Serial No. 10-509  
NSSL/WEB R0  
Docket No. 50-423  
License No. NPF-49

**DOMINION NUCLEAR CONNECTICUT, INC.**  
**MILLSTONE POWER STATION UNIT 3**  
**RESPONSE TO REQUEST FOR ADDITIONAL INFORMATION REGARDING**  
**GENERIC LETTER (GL) 2004-02**

**MILLSTONE POWER STATION UNIT 3**  
**RESPONSE TO REQUEST FOR ADDITIONAL INFORMATION REGARDING**  
**GENERIC LETTER 2004-02**

**Millstone Power Station Unit 3 (MPS3) Head Loss and Vortexing RAI 6**

Figure 1: Debris Bed Head Loss vs. Time for Test M3-C1

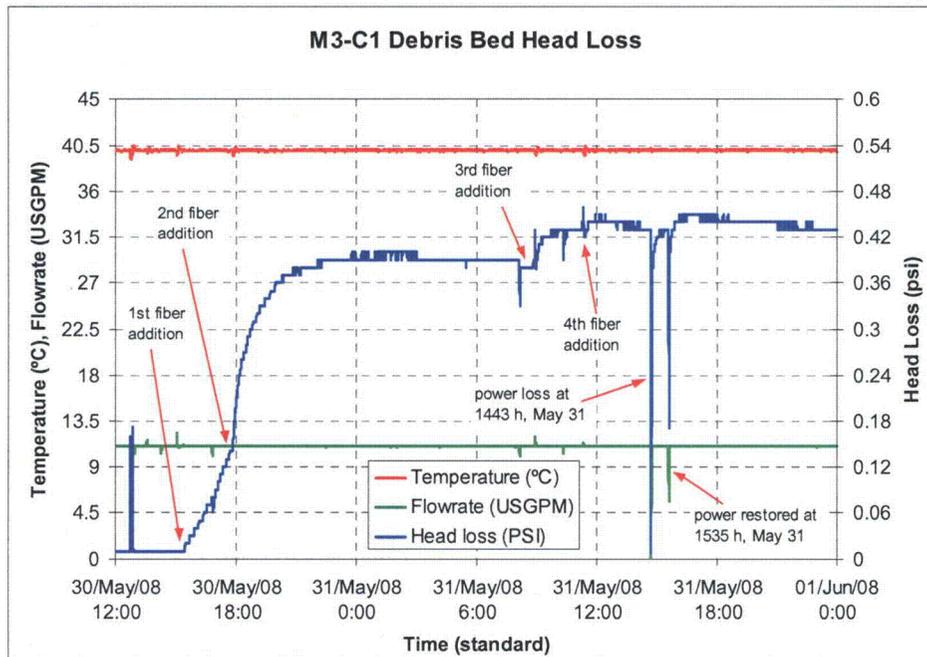
*The December 18, 2008, DNC letter provides contradictory information on the amount of fibrous debris added during the test. On page 8, Attachment 2, it is stated that the limiting bed was determined to be 1/4 inch during earlier testing. Yet the same paragraph states that only two increments, containing fibrous debris to form 1/16 inch bed each, were added to the test and that no further fiber was added. Page 16 states that two 1/16 inch additions were made and implies that two further additions were made later. In addition, the graph on page 19 shows 4 fibrous additions. Describe, in detail, the initial fibrous debris conditions of the test and the amount of any additions that were made during the test.*

The December 18, 2008, DNC letter states that the limiting thin bed for MPS3 is 1/4 inch as determined by previous testing. However, the head loss plot on page 19, Attachment 2, indicates that the third and fourth 1/16 inch fiber additions had little effect on head loss. Please evaluate the thin bed thickness for MPS3 in consideration of these points. Also, if the thin bed for the Rig-89 test is different from that of other tests that were used to provide Rig-89 test inputs, please provide an evaluation of how the final qualification test could have been affected by the use of such inputs. The licensee's assertion that 55% of the debris attached to the strainer for the Rig-89 test, and 72% and 84% attached to the strainer for the reduced scale test should also be considered in this evaluation.

For the MPS3 Rig 89 chemical effects test M3-C1, four fibrous debris additions were made to the test loop to achieve a thin bed thickness of 1/4 inch as determined by previous thin bed tests. The first fiber addition (1/16 in. (1.6 mm)) was made at 1504 h, May 30, 2008, after the addition of the particulate debris. The second fiber addition (an additional 1/16 in. (1.6 mm)) was made at 1750 h, May 30, 2008. The third and the fourth fiber additions (1/16 in. (1.6 mm)) were made at 0856 h and 1120 h, May 31, 2008, respectively. The detailed debris addition information is also indicated in the head loss vs. time curve as shown in Figure 1.

As shown in Figure 1 (response to RAI 6 Item 1), the debris bed head loss increased from 0.38 psi to 0.43 psi after the third fiber addition, indicating that the thin bed thickness was at least equivalent to three additions. After the fourth fiber addition, the head loss peaked at 0.45 psi and stabilized at 0.43 psi before the first chemical addition. This indicates that the fourth addition made little difference and the thin bed could be considered to be less than 1/4 inch.

Figure 3: Calcium Release Data from MPS3 Dissolution Tests without TSP at 90°C

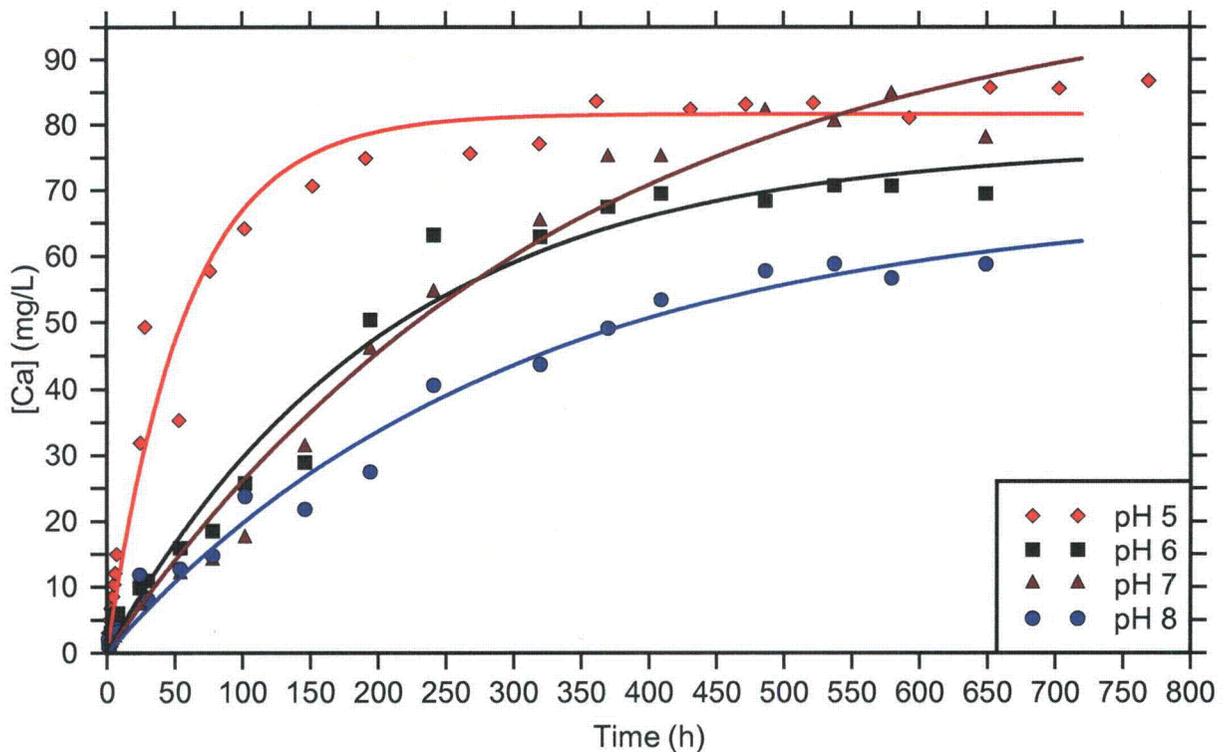
*The solubility data for calcium shows increased dissolution at lower pH ranges. In table 0-2, Attachment 2, to the December 18, 2008 letter, the calcium concentrations for pH 5.0 and 6.0 are lower than the concentration for pH 7.0. In addition, page 11 of 30 states that the concrete samples in the beaker tests fully dissolved in the pH 5.0 and 6.0 tests but were not fully dissolved in the pH 7.0 and 8.0 tests. Please explain why the bench tests at lower pH ranges, in which the concrete fully dissolved, resulted in lower concentrations of dissolved calcium than the bench tests at higher pH ranges, in which the concrete did not fully dissolve.*

surface area-to-volume ratio<sup>i</sup> do show higher dissolution rates at lower pH ranges, but the ultimate concentrations reached were lower in the tests at pH 5 and 6 than in those at pH 7 and 8 (Figure 3). This apparent contradiction can be explained by the small size of the coupons used: (each coupon measured approximately 0.4×1.2×0.5 cm, and were small in comparison to similar tests performed for MPS2). As a result of their limited size, two of the coupons completely dissolved in the pH 5 and 6 tests. Additionally, their small size made them more prone to containing non-uniform proportions of rock and mortar. Consequently, the calcium concentrations measured toward the end of the pH 5 and 6 tests represent the natural limit when all of the concrete had dissolved. The data from all of the tests were fit to Equation 1. The early plateau seen in Figure 3 for the pH 5 and 6 tests biased their extrapolated concentrations at t=∞ shown in Table 1 (Table O-2 of the above-mentioned report).

The recovery of coupons from the pH 7 and 8 tests, and the lack of any obvious plateau in Figure 3, strongly implies that the results of these more important tests were not biased by a limited calcium source. The results of the pH 7 test, in particular, were used in the design of the reduced-scale test, as pH 7 is the minimum allowed sump water pH. However, it should be noted that this remains a conservative estimate of calcium release since the MPS3 sump pool is likely to remain mainly above pH 8.

Figure 4: Calcium Release Data from MPS3 pH 7 and pH 8 Dissolution Tests  
(without Tri-Sodium Phosphate (TSP)) @ 90°C

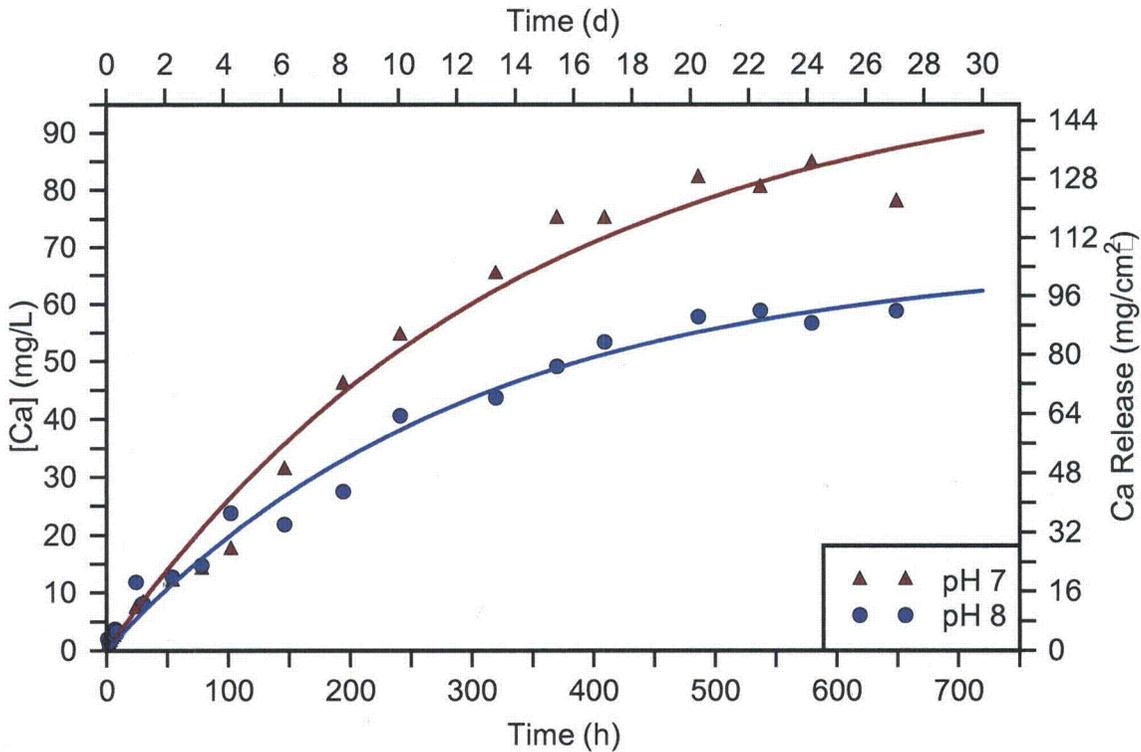
*For MPS3, the calcium dissolution test at pH of 7.0 resulted in a 30-day calcium concentration of 78 mg/L. The December 18, 2008, letter states that the pH 7.0 case (without TSP present) was used to determine the concentration of calcium in the Rig-B9 test. However, the calcium concentration used for Rig-89 testing was 14.7 mg/L. Please justify why 14.7 mg/L is a representative value in the Rig-89 testing when the dissolution testing conducted with scaled quantities of concrete resulted in a calcium concentration of 78 mg/L.*

Because the concrete SA/V ratio for containment differs from that tested, the results obtained are non-representative but may be appropriately scaled. Normalization of the dissolution test data may be performed by dividing the results (in mg/L) by the SA/V ratio (0.64 cm<sup>2</sup>/L), as indicated by the right-hand vertical axis in Figure 4. Similarly, the fit to the calcium concentration data described below, may also be normalized to produce a calcium release equation. Thus, the 30-day calcium release per unit area of concrete can be read from the figure or calculated from the fit and used to calculate the calcium release from a known surface area of concrete.

Figure 4 also shows the curve fits to the data represented by Equations 2 and 3. These were determined using robust fitting procedures within TableCurve 2D<sup>†</sup> that reduce the fitting errors caused by data outliers. The constants found within Equation 2 were reported in Table 2-5 of the bench-top test report [3] and Table O-2 of DNC's December 18, 2008 letter. Equation 3 may be calculated from Equation 2 by dividing the initial constant<sup>ii</sup> by the tested surface area-to-volume ratio, 0.64 cm<sup>2</sup>/L.

Figure 6: 3D Illustration of the WCAP Aluminum Release Model

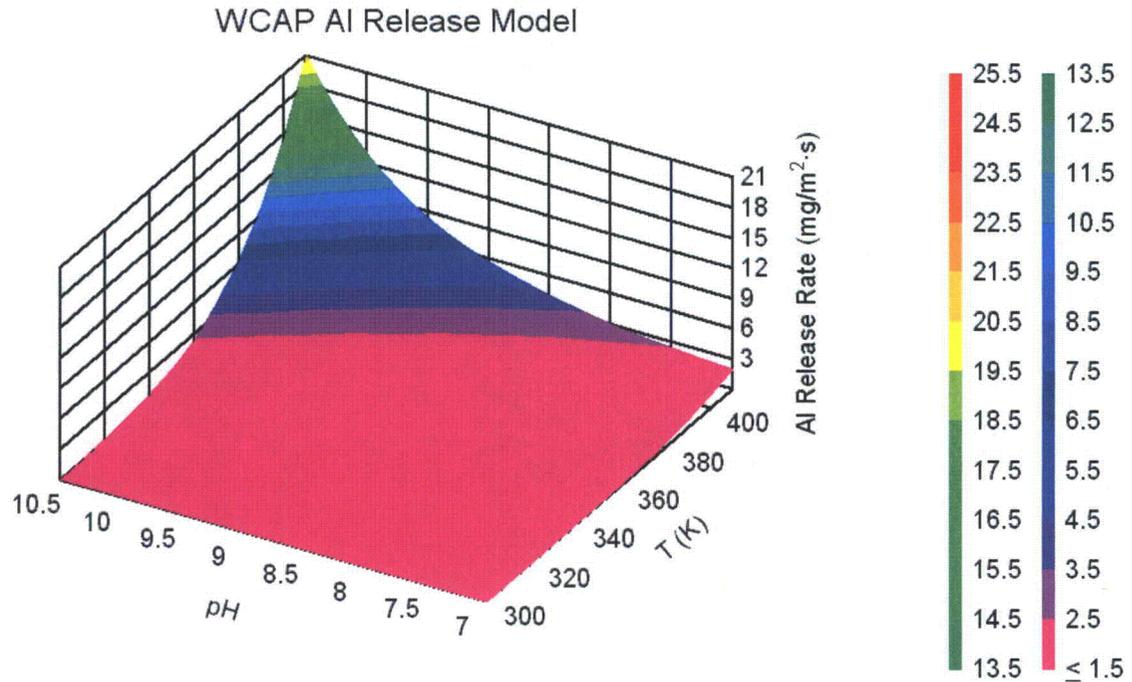
*Please compare the total amount of aluminum that is predicted to be released by the AECL model with that predicted by the WCAP-16530 base model (i.e., no refinements for silicate or phosphate inhibition). Discuss any significant differences between the plant-specific predictions for the two methods, including the acceptability of these differences.*

The WCAP-16530 base model is an empirical model of the aluminum release rate (RR) based on the data set described by Lane et al [5], which included data from ICET 1, CR-6873, WCAP-7153A and WCAP-16530. The WCAP model is described by Equation 4 and the results are shown in Figure 6.
